**Bridgemaster Axle Bolt Torque
Inspection****Date:** February 22, 2022**Bulletin Name:** MXR-TSB-029**Model:** Bridgemaster V model 93**Model Year:** 2020-2021**Units Affected:** Units with standard bolts
(not Huck Bolts)**Purpose:**

Inspection and possible rework required on certain bolts on the Bridgemaster® V axle regarding torquing specifications.

Figure 1

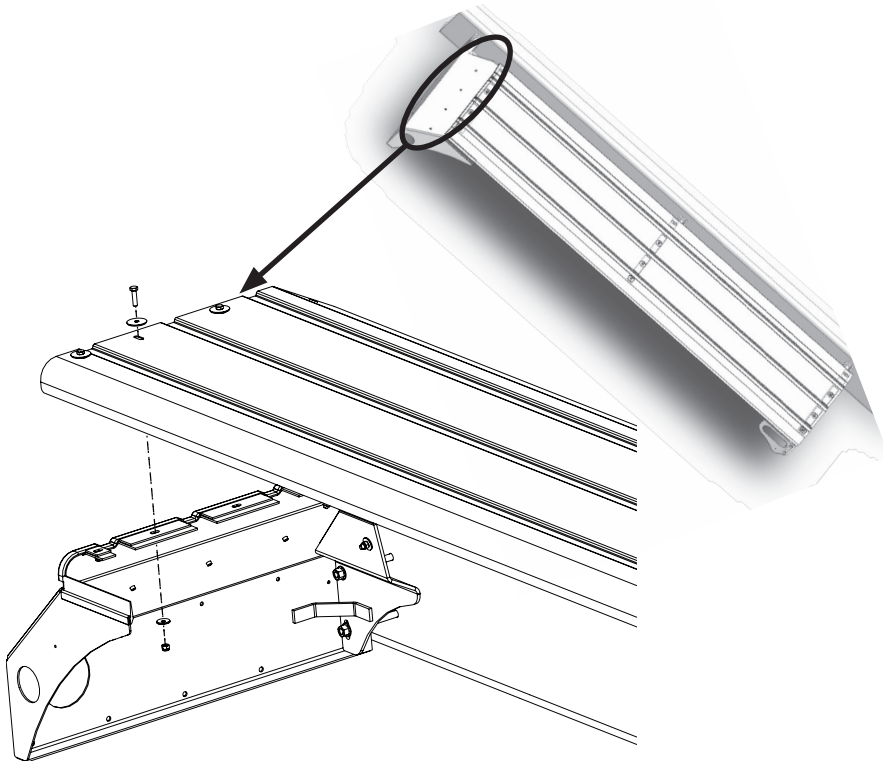
1. Place the mixer on flat, level ground. Lower the Bridgmaster axle to the ground and make sure that the Bridgmaster pressure is at the lowest setting.
2. Perform your company's Lockout/Tagout procedure. If your company does not have a Lockout/Tagout procedure, follow OSHA 1910.147 and 1910.146 Confined Space as appropriate.
3. Remove both tandem axle fenders by
 - a. Removing and retaining the sets of hardware in Figure 1. There are four pieces of hardware per set (bolt, washers, nut), and 15 sets total per fender. **NOTE:** Be aware of any rubber cushions between the fender "skin" and the mounting bracket that may have come loose or stuck to the skin. Do not lose any cushions; reinstall them if they have come loose.
 - b. Using two people, remove each fender and set each aside.

5. Reinstall the tandem axle fenders by
 - Reinstalling the fender skins (use two people to move them into place).
 - Reinstalling the sets of hardware as shown in Figure 1.
 - Torque the hardware to 13 ft.-lbs.
6. Rework is complete. Remove your company's Lockout/Tagout procedure. If your company does not have a Lockout/Tagout procedure, follow OSHA 1910.147 and 1910.146 Confined Space as appropriate. Return truck to service.

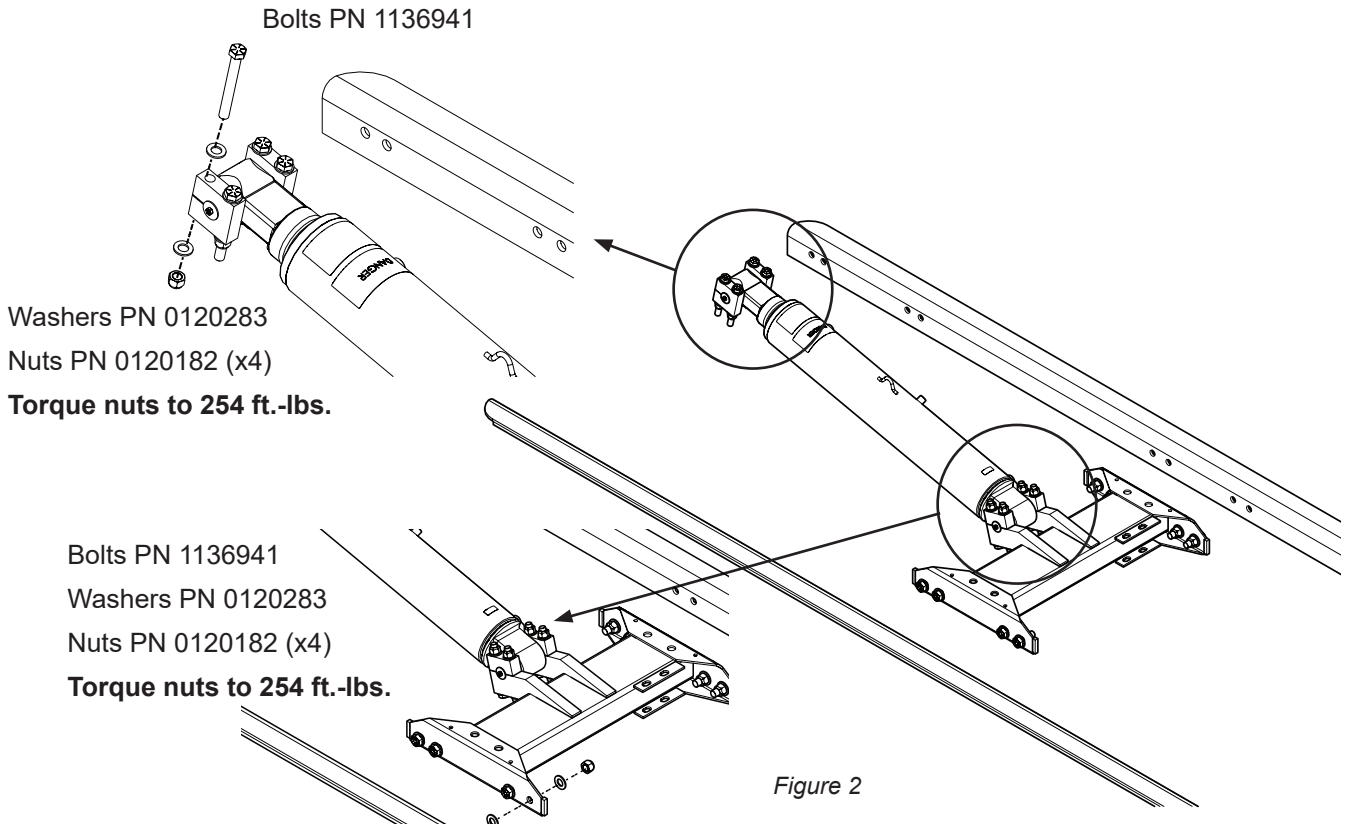
4. Use the torque wrench to check the torque of **each hardware** as called out in Figure 2 and Figure 3.
 - If the torque specification is accurate for **each** hardware, then the inspection is complete and the truck can be returned to service.
 - If **any** hardware was not torqued to the specification, then that hardware must be replaced.

NOTE: Make sure to check the torque of each set of hardware called out (four sets on each end of the cylinder).

- Use the torque wrench to torque to the proper specifications (as shown in Figures 2 and 3). Make sure to torque the hardware from the nut side.

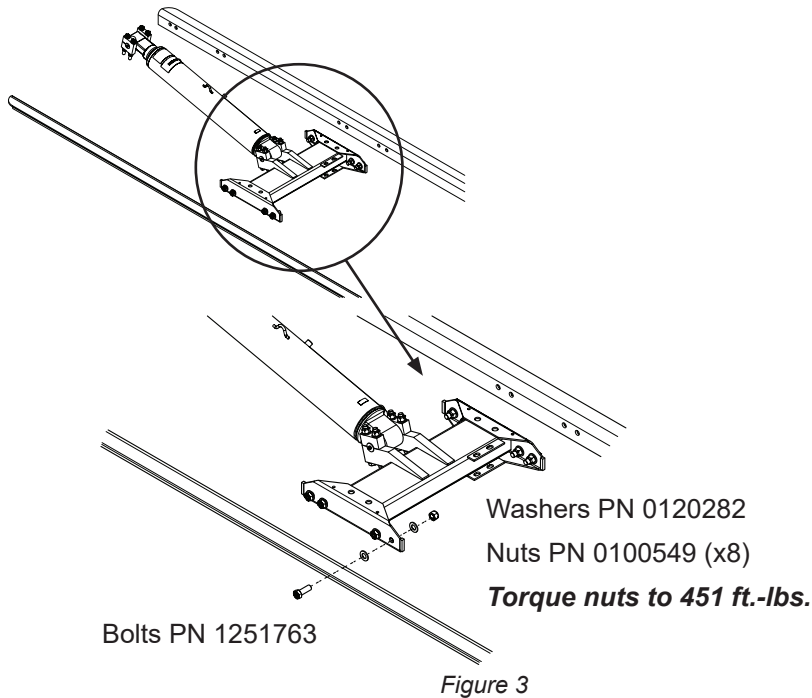
NOTE: If the Bridgemaster truck has Huck fasteners, then there is no need to inspect these for the cross member.

NOTE: Make sure to check the torque of each set of hardware called out in Figure 3 (eight sets total).
